NOTICE OF PUBLIC HEARING
CITY OF ALBANY
LANDMARKS ADVISORY COMMISSION

Historic Review of New Construction (HI-04-11)

Historic Review of Exterior Alterations (HI-06-11)

Historic Review of Exterior Alterations (HI-07-11)

BUILDING ELEVATIONS

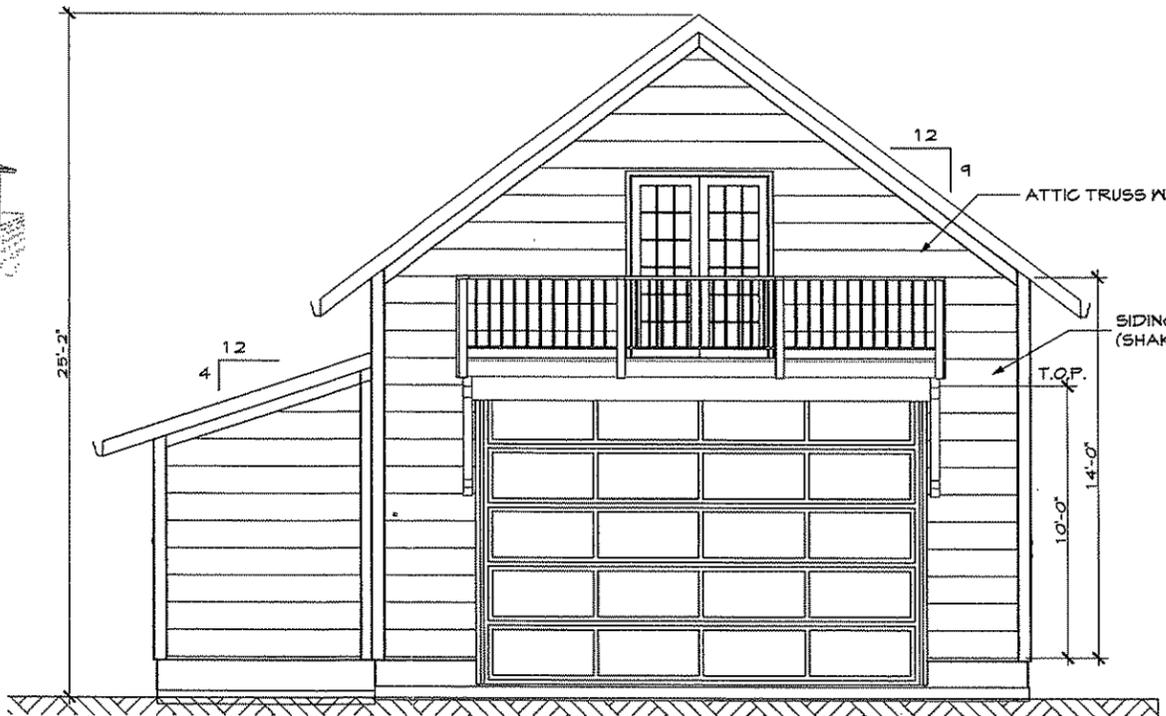
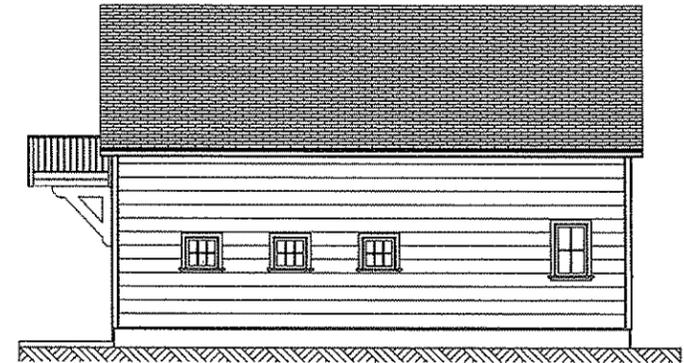
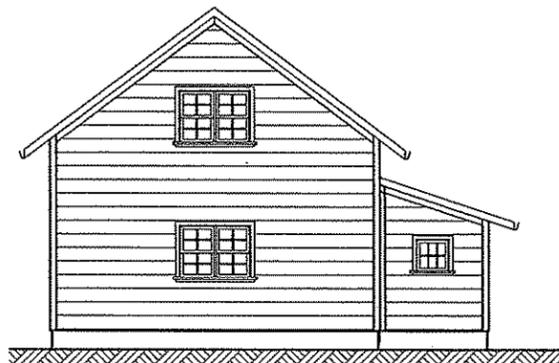
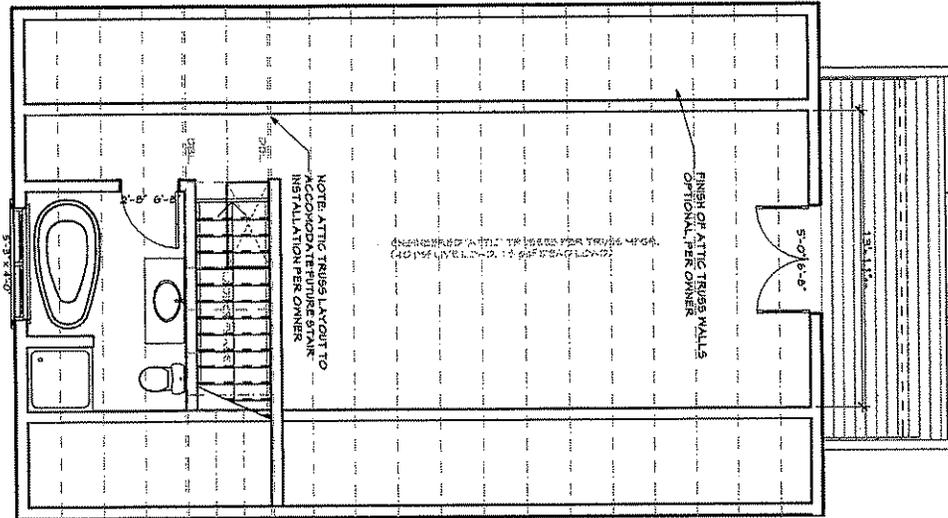
13. The scale of the building is minimized by including a two-story portion and a one-story shed roof wing. The main “body” of the garage is proposed to be 24 feet wide by 38 feet deep. The one-story “wing” is 8 feet by 18 feet that would be recessed from the south elevation by 16 feet. The wall height of the main body is proposed at 14 feet, with a 9 over 12 roof pitch, bringing the total height to 23.5 feet. The one-story wing would have 8-foot walls and would tuck under the roof.

14. Building Design and Materials. Windows are proposed in the roof gables to break up the scale of the gable ends. The south elevation includes first floor windows. Four multi-paned windows are proposed facing west or east on the first floor to break up the scale of the building on these sides. The gable roof and multi-paned windows complement the architecture of the house on the property.

15. The design includes shingle siding to match the type and reveal of the siding on the house on the same property.
16. A cantilevered balcony facing the alley is proposed. It is not visible from the street and the building is setback from the alley property line by 20 feet. A two-car garage door is proposed facing the alley.

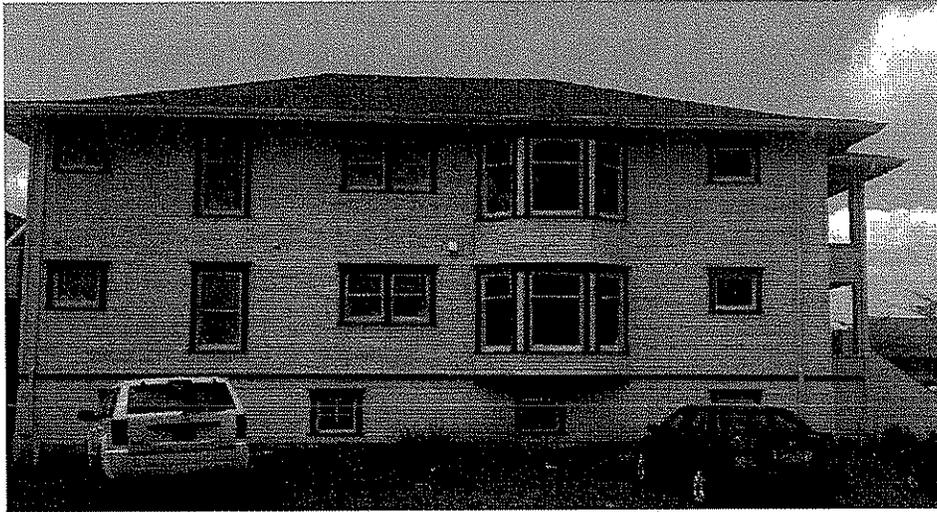
2. The building was raised approximately 3 feet in 2007, historic review case file HI-07-06. New front and back stairs are needed to accommodate the increase in building height. These front and back stairs did not go through the historic review process and are the subject of this application.

3. Front handrail. Prior to the building being raised several feet, there was a simple piped-handrail design. The current handrail shown in the above picture is the “wall” design that matches the front porch wall, and is continued down the stairs. This style is commonly found on Craftsman buildings, with the exception of how this meets the front porch, it is much higher than the porch wall.

4. The applicant is asking that the current design be approved, or the proposed modification as drawn on the attached page. Staff has discussed the modified design proposal with the Building Division staff. The design below cannot meet building code minimum guardrail height of 42 inches. The wall height that the rail would match is only 18 inches. Getting to 42 inches will require a different design. Given code requirements, **staff has concluded that the current design is likely the most compatible in style when compared to alternative designs** that meet the code requirements.

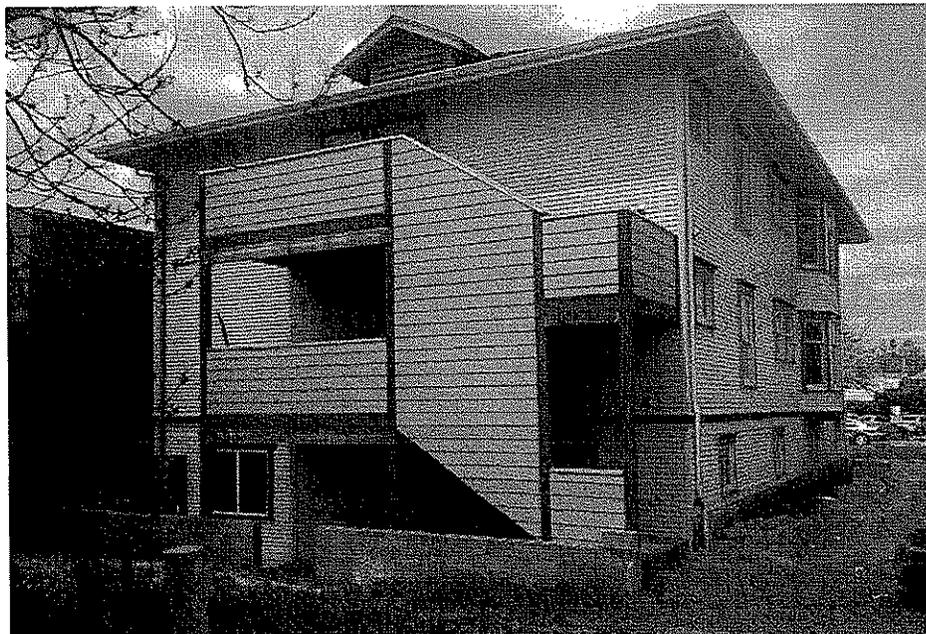
6. Back stairs. The applicant proposes the back stair design as shown in the picture below, and painted to match the paint color on the main building. The applicant talked with a contractor about adding trim to cover up the columns and the brackets. The contractor recommended against this idea because of the chances for water damage.

1. The back stairs shall be painted to match the paint used on the main building.
2. The front porch wall guardrail shall be designed to be limited in visibility in order to avoid changing the character of the front façade. Staff recommends Plexiglass or a system of thin wires be used to meet the Code requirements.
3. The Preservation Planner must approve the guardrail design for the front porch and front stairs.
4. If the back stairs need to be replaced or repaired in the future, historic review will be required.

FRONT
LABOR TEMPLE PORCH

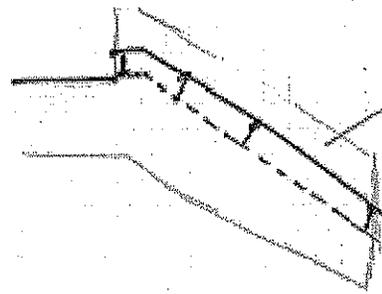
① REMOVE THIS ^{add appropriate} HEIGHT OF PORCH RAIL CAP WITH WOOD.

② ADD Handrail (LAC to guide material/design) to meet building code
 a) Height
 b) handrail present (no handrail now)
